## V2500-A1/A5 SERIES PROPULSION SYSTEM SERVICE BULLETIN

This document transmits Revision 2 to Service Bulletin EV2500-72-0435 and Revision 2 to the Supplement

# V2500-ENG-72-0435

ENGINE – LP COMPRESSOR – INTRODUCTION OF FAN CASE, PANEL AND BRACKET SCALLOPED FOR  
NO.4 SCAVENGE TUBE REROUTE

Before and after alteration of Fan Case  
Figure 1

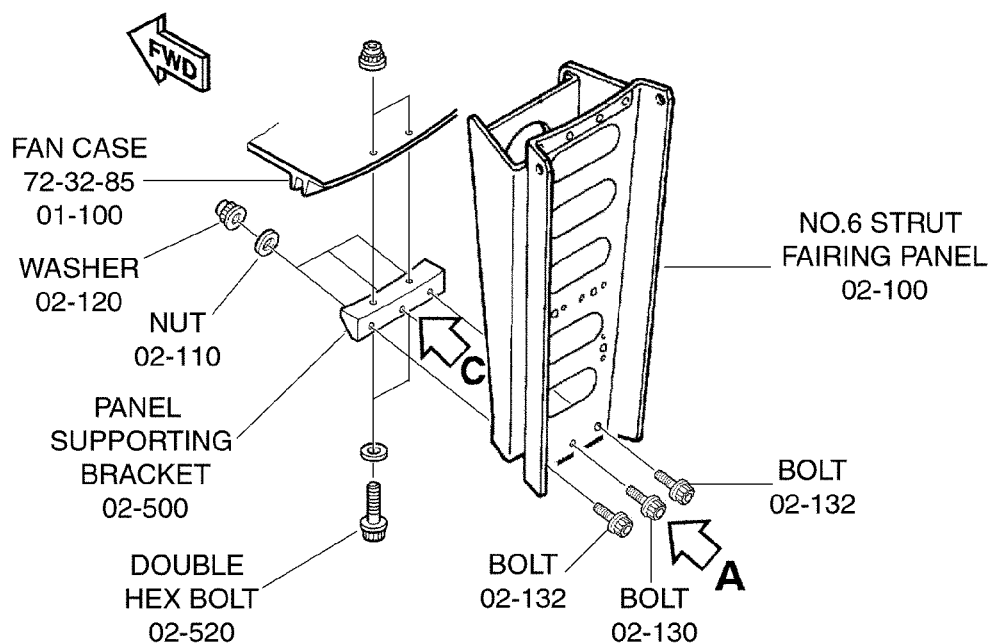
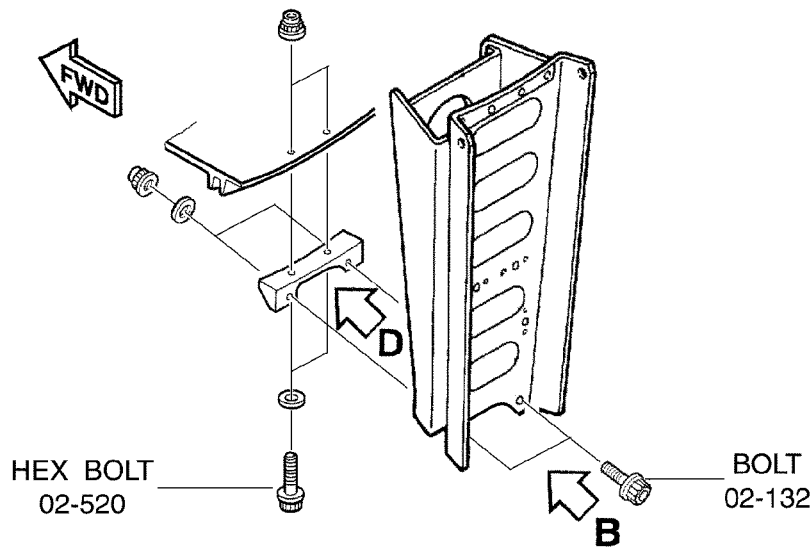
- (1) The changes introduced by this Service Bulletin are as follows:
- (a) The profiles of the Fan Case, the No.6 Strut Fairing Panel and the Panel Supporting Bracket are changed to make scalloped contours to avoid interference with new No.4 Bearing Scavenge Tube. Refer to Figure 1.

Before and after alteration of No.6 Strut Fairing Panel, Panel Supporting Bracket  
Figure 2 (Sheet 1 of 3)

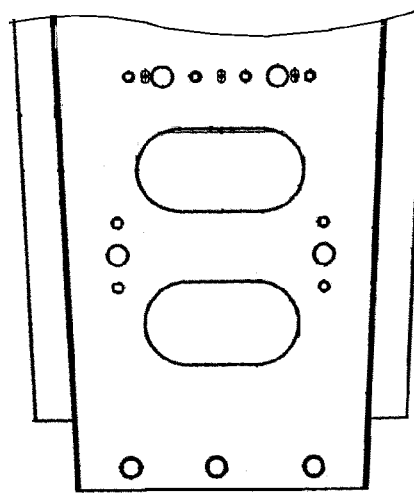
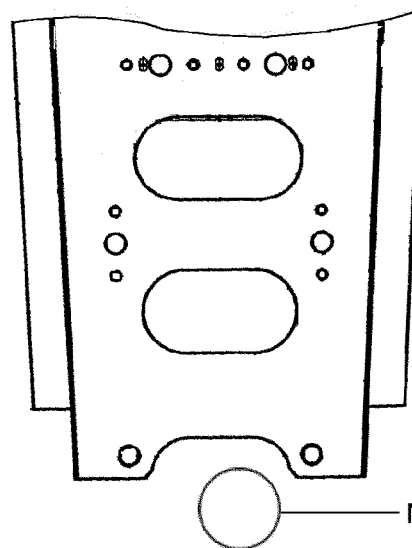
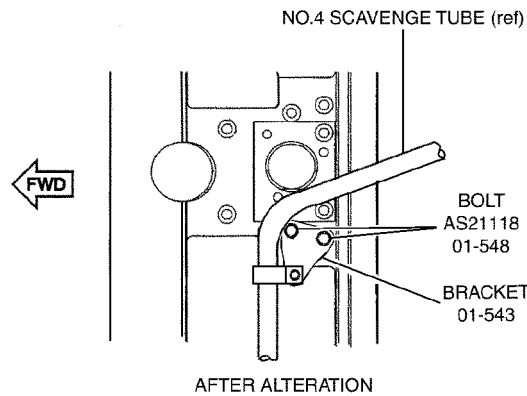
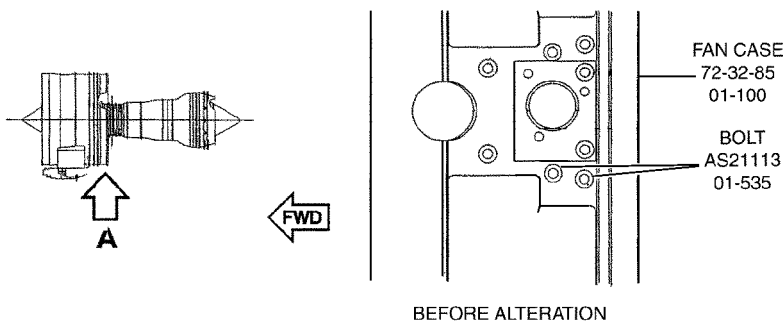
- (b) The part numbers and quantity of the attaching parts (Bolts, Nuts and Washers) associating the No.6 Strut Fairing Panel and the Panel Supporting Bracket are changed. Refer to Figure 2 and Figure 3.

LENGTH OF NEW BOLTS ARE LONGER  
THAN LENGTH OF EXISTING BOLTS.

Before and after alteration of new Bracket and Bolts  
Figure 3

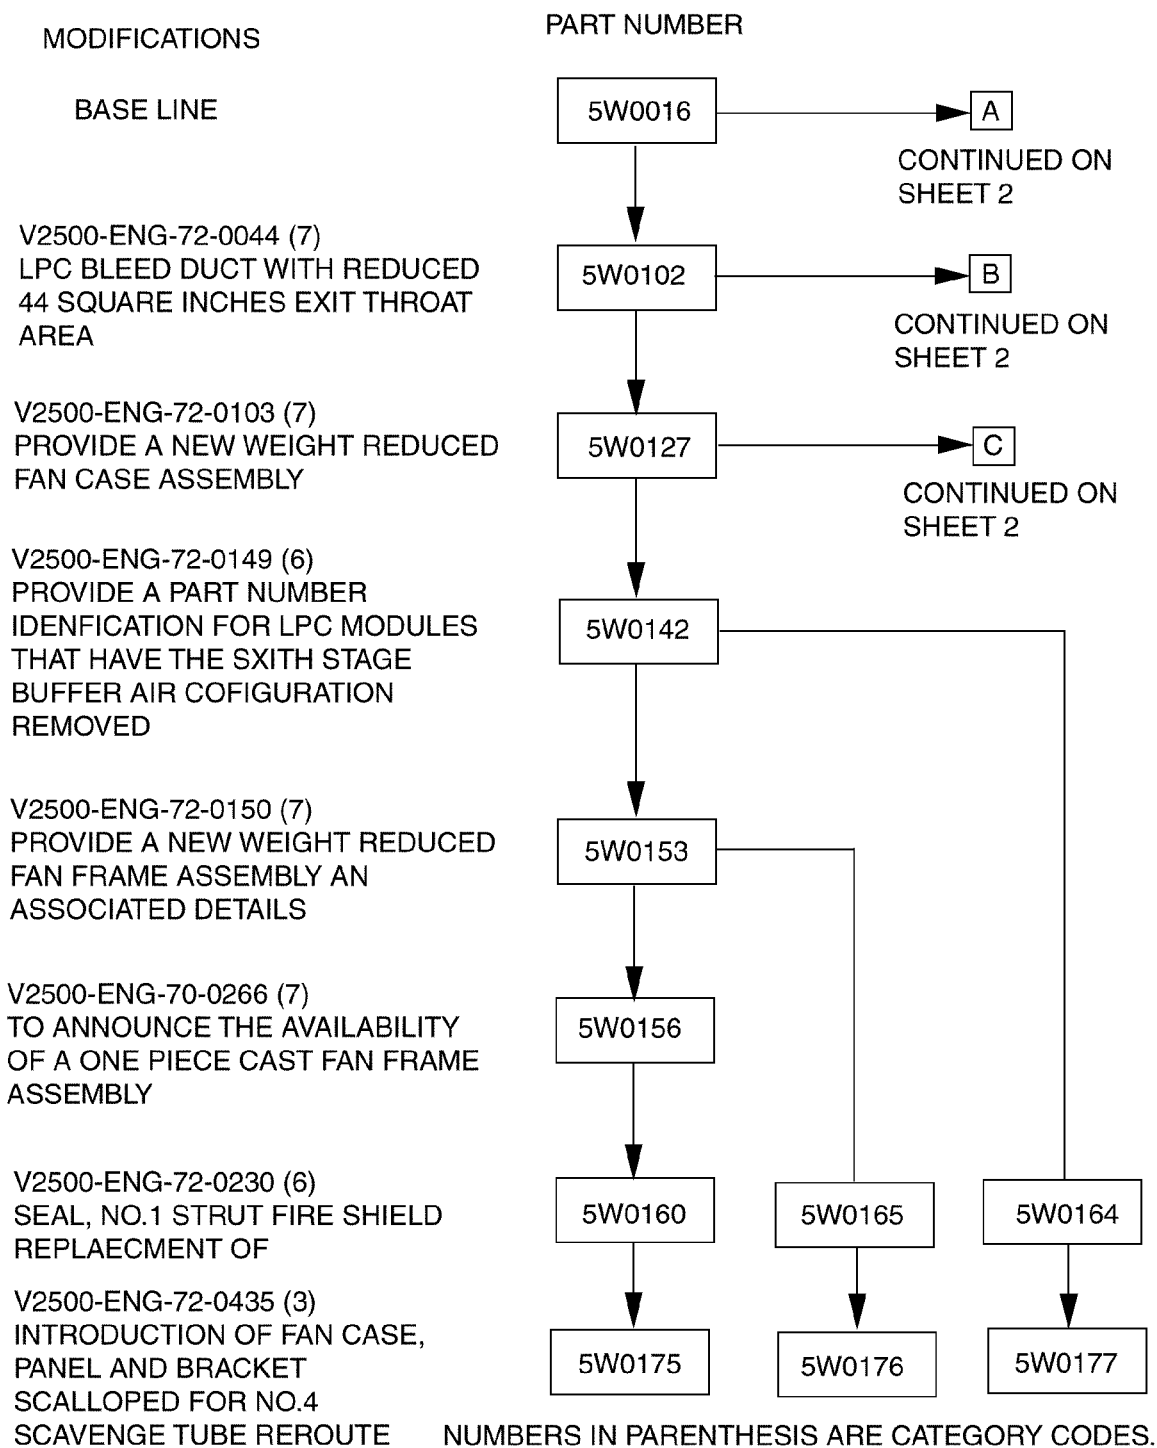
- (c) The new Bracket 5A1884 and attaching parts are added. Refer to Figure 3.
  - (d) The Module Assembly numbers (Module Identification numbers) of the LPC/Intermediate Module are changed.

Location of new 5A1884 Bracket  
Figure 12

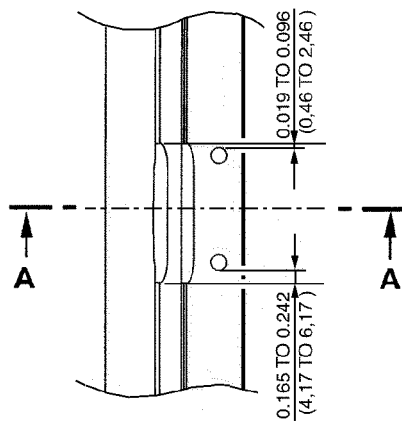
- (1) Install the new 5A1884 Bracket (72-32-00, 01-543) with new two Bolts (72-32-00, 01-548) on to the Fan Case. Refer to Figure 12 and 26.
- (a) Install the new 5A1884 Bracket (72-32-00, 01-543) with new two Bolts (72-32-00, 01-548) on to the Fan Case. Torque the Bolts to 180 to 220 lbfin (20,00 to 25,00 Nm).

Rework and reidentification of Fan Case  
Figure 13 (Sheet 1 of 2)

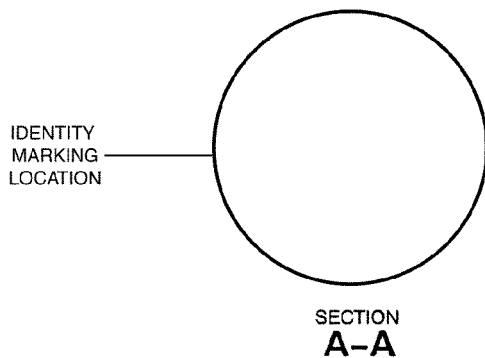
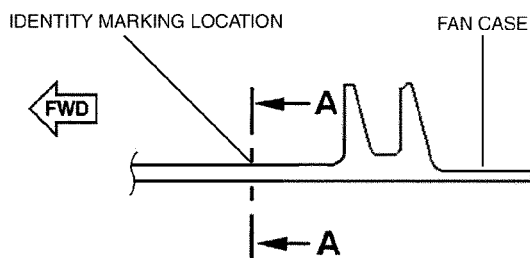
- (2) Existing Fan Case, No.6 Strut Fairing Panel and Panel Supporting Bracket can be reworked. Refer to Figure 13 to 15.
- (3) For relationship with other Service Bulletins, see 1.K. References and Figure 4 to 10 Family Tree.

Refer to Figure 17.  
Use IAE 3J12860 Guide, Scalloping
  - (f) Remove the material along the line which was marked in step C.(3)(c)

- (n) Cancel the existing part number and re-identify with a new part number which is followed by the Letters 'Fan Case' adjacent to the existing part number  
Refer to Figure 13  
Use the Vibro-peen method

Existing	Re-number
5W0069	5W0187
5W0070	5W0185
5W0072	5W0190
5W0081	5W0189
5W0093	5W0186
5W0094	5W0188
5W0100	5W0184
5W0124	5W0191
5W0168	5W0192
5W0171	5W0193
5W0144	5W0194
5W0149	5W0195
5W0169	5W0197
5W0172	5W0198
5W0154	5W0196

Rework and reidentification of No.6 Strut Fairing Panel  
Figure 14

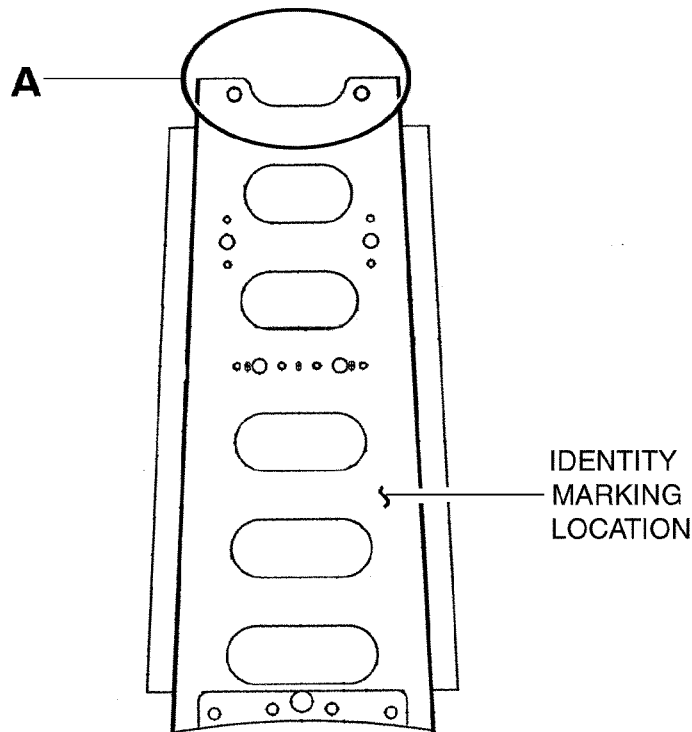
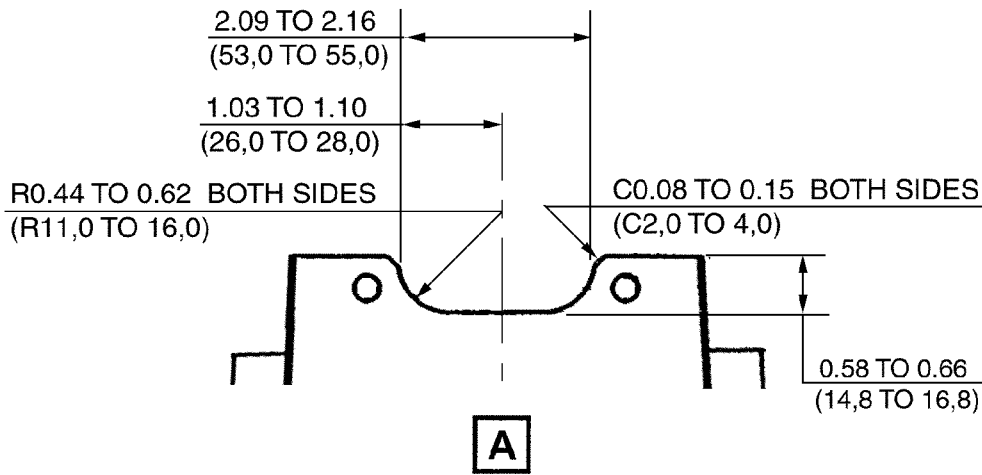
| (e) Remove the material along the line which was marked in step C.(4)(b) | Refer to Figure 14                                       |

| (i) Dimensionally examine the reworked area. The area to be reworked must be between the minimum dimension line and the maximum dimension line on the Gage | Refer to Figure 14 and 21   |
| (n) Cancel the existing part number and re-identify with a new part number that is marked adjacent to the existing part number                             | Refer to Figure 14<br>Use the Vibro-peen method   |

| (n) Cancel the existing part number and re-identify with a new part number that is marked adjacent to the existing part number                             | Refer to Figure 14<br>Use the Vibro-peen method   |
- |          |           |
| Existing | Re-number |
| 5A1838   | 5A1885    |
| 5A2184   | 5A1898    |

Rework and reidentification of Panel Supporting Bracket  
Figure 15

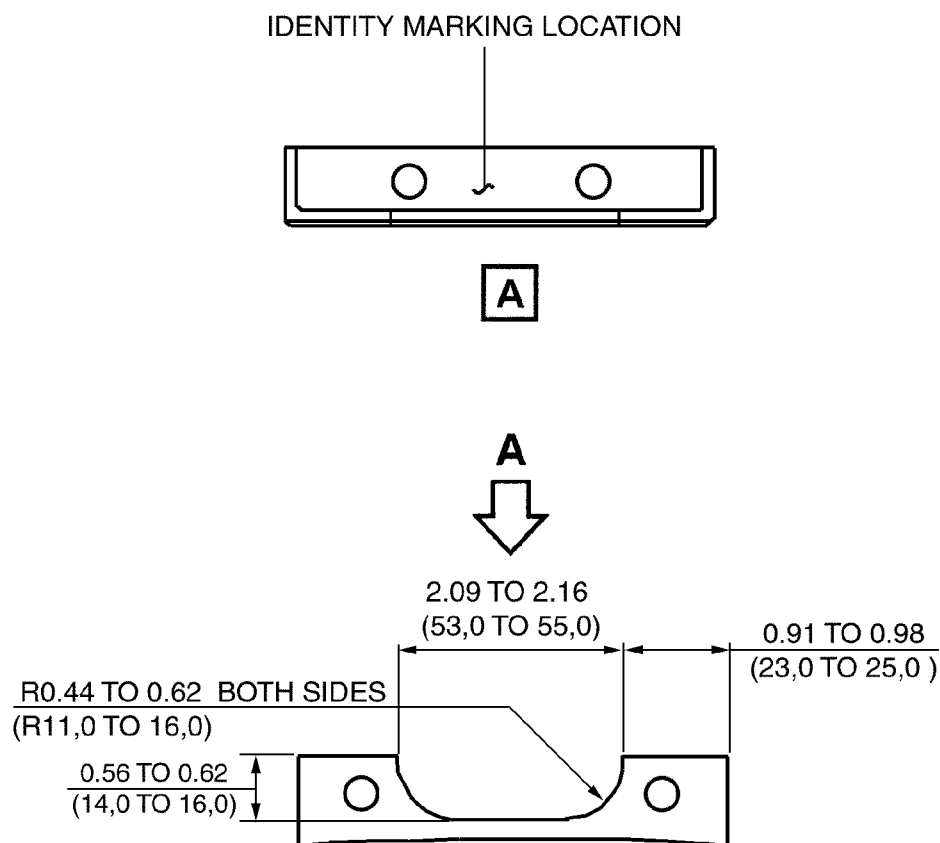
| (e) Remove the material along the line which was marked in step C.(5)(b) | Refer to Figure 15 |

| (i) Dimensionally examine the reworked area. The area to be reworked must be between the minimum dimension line and the maximum dimension line on the Gage | Refer to Figure 15 and 24 |

- |  |  |          |           |        |        |
|--|--|----------|-----------|--------|--------|
| (n) Cancel the existing part number and re-identify with a new part number that is marked adjacent to the existing part number | Refer to Figure 15<br>Use the Vibro-peen method  |          |           |        |        |
|  | <table border="0"> <tr> <td style="text-align: center;">Existing</td> <td style="text-align: center;">Re-number</td> </tr> <tr> <td style="text-align: center;">5A1749</td> <td style="text-align: center;">5A1886</td> </tr> </table> | Existing | Re-number | 5A1749 | 5A1886 |
| Existing   | Re-number  |          |           |        |        |
| 5A1749   | 5A1886   |          |           |        |        |
